ELECTRONICS FIELD CHANGE BULLETIN
NAVAL ELECTRONIC SYSTEMS COMMAND
WASHINGTON, D. C.

AN/FRT-39
AN/FRT-40
AN/FRT-62

PURPOSE: This modification provides remote on/off control of the transmitter carrier. In addition, the unit provides an indication of transmitter status by means of signals to a display board located at the transmitter monitor control console or elsewhere at the transmitter site. In order to accomplish this modification, Tone Intelligence Unit Model TIS-3 is physically replaced by Transmitter Keyer Monitor Control Unit. Tone Intelligence Unit TIS-3 will be relocated to the CCL facilities at the transmitter site or to some other remote location.

Figure 4.

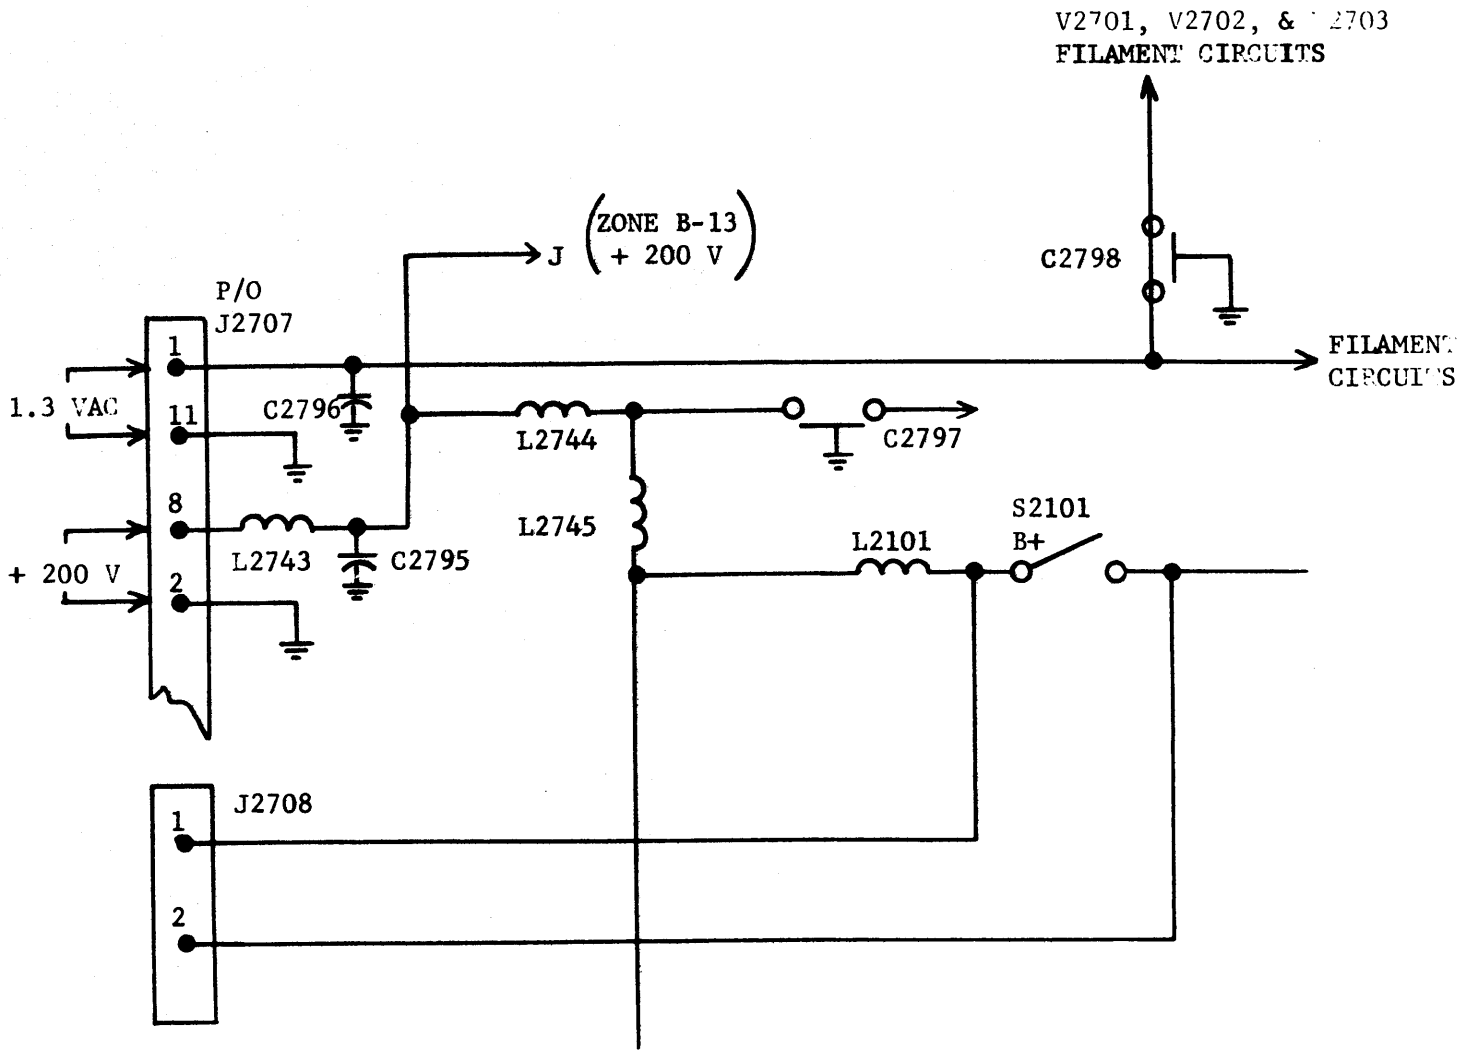
(a) Figures III(A)-4-5b, III(A)-4-6b, and III(A)-8-1b should be changed in accordance with the information provided in figure 4.

NOTE
 Cable 67 to terminal 12
 TB102 (KMCU-2) CON-
 NECTED but not used.
